WHISTLING NOISE NEAR TOP OF MAIN DOOR

Consumer reports air leakage or whistling noise near top of main door. Problem is caused by gap between door and gasket. Problem can occur in AEG One Tumble Dryers with transparent door and serial number up to 650xxxxx.

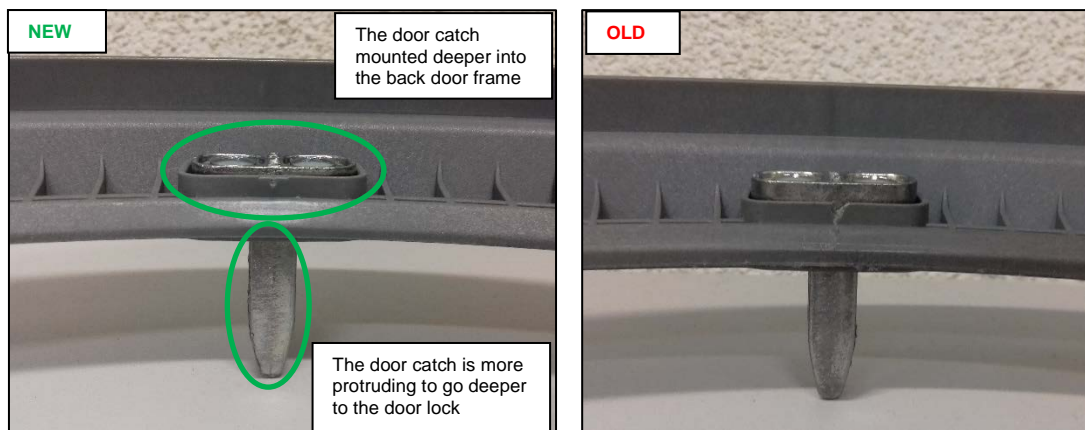
New door gasket is bigger and adheres better to door surface.

New door pestle is longer and reduces possibility of drying cycle interruption.

New back door frame let the door catch go deeper to the door lock while door closed. This should solve the problem with "self-opening" door after using new bigger gasket. See picture below please.

Replace door gasket and door pestle as well as back door frame.
